PROJECT/TITLE  
**BUDGET CAR RENTAL**  
305 AMERICAN BLVD. WEST  
BLOOMINGTON, MINNESOTA

SHEET TITLE  
**EXISTING  
CONDITIONS &  
DEMO PLAN**

CASE FILE #PL201700125

1 A1 PROPOSED BUILDING PLAN SCALE:

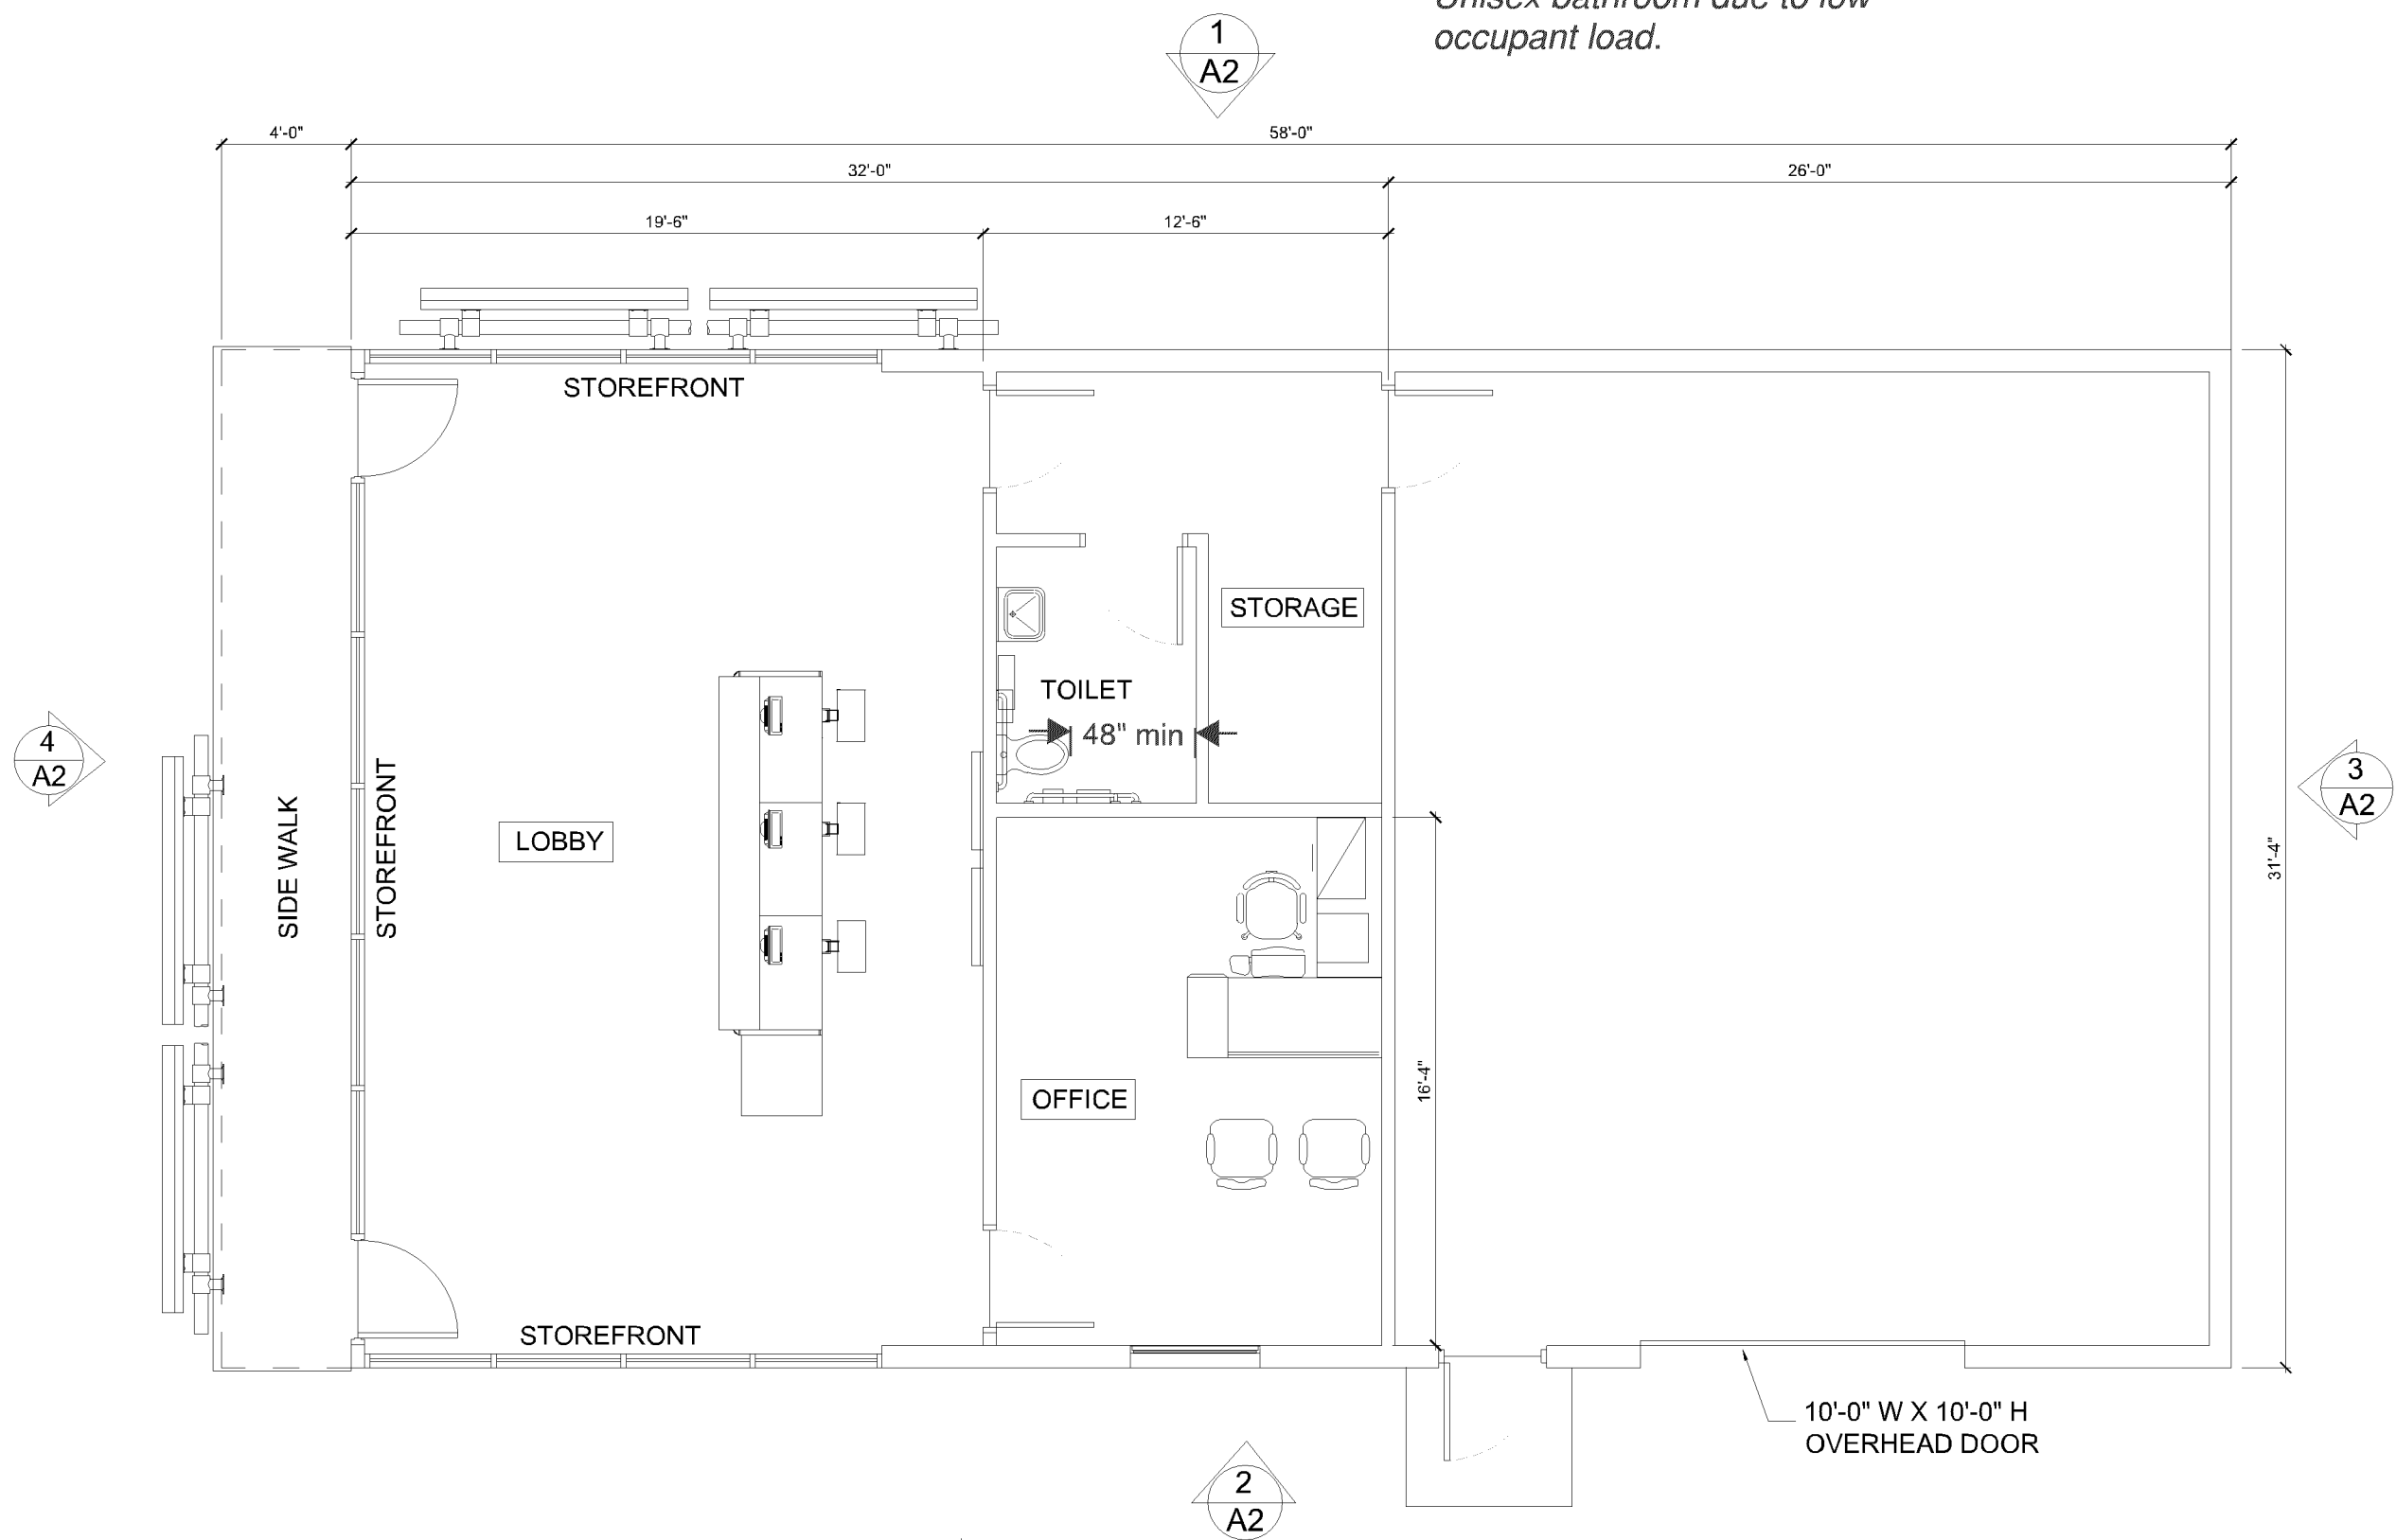
Per MN amendment. Ok for  
Unisex bathroom due to low  
occupant load.

Interior trash consistent with Section  
19.51 of the City Code and the MN  
State Building Code must be provided.

1 NORTH ELEVATION

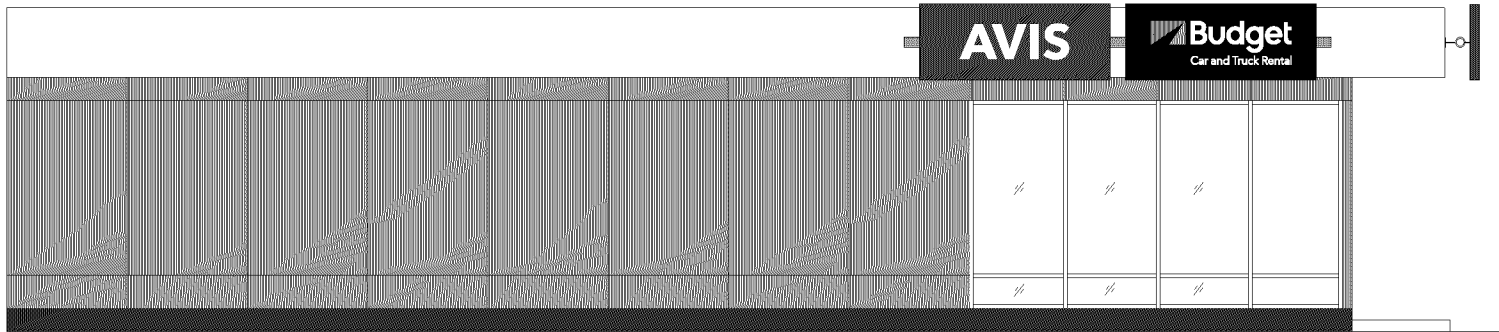
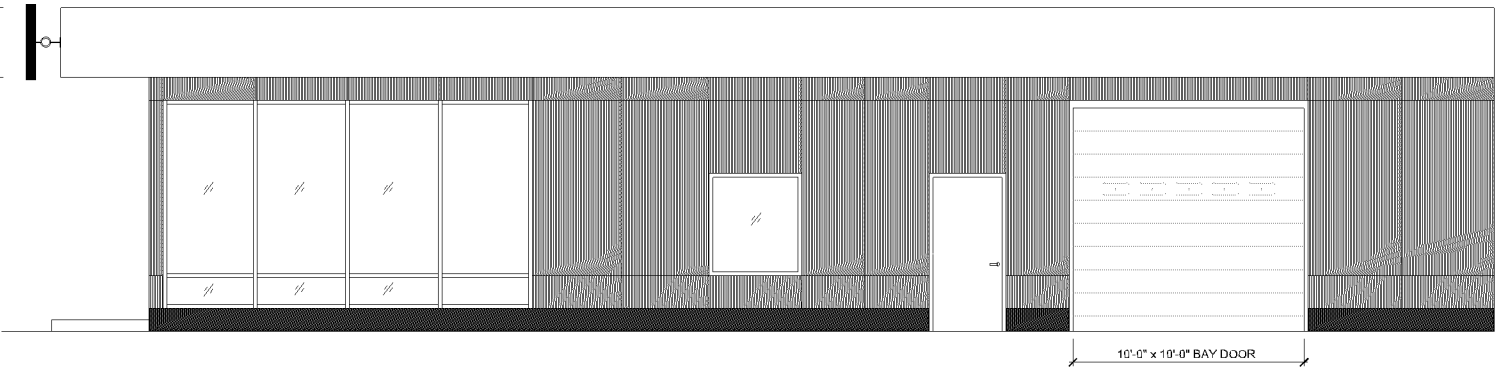
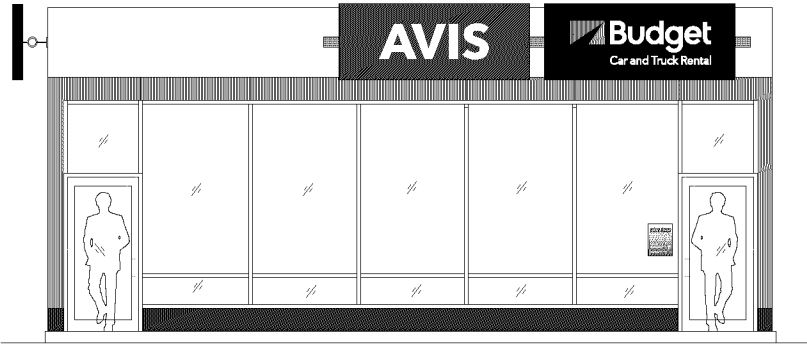
Any use of acrylic finish over portland cement stucco must comply with Section 19.63.08(h) of the City Code.

Signs must comply with Chapter 19, Article X Sign Regulations. When utilizing cabinet wall signage, you are limited to one sign per building elevation. The maximum amount of wall signage utilizing cabinets is 35.2 square feet for the western elevation and 65.2 square feet for the northern elevation. Signs must not extend above the roof-line. Separate sign permits must be obtained.
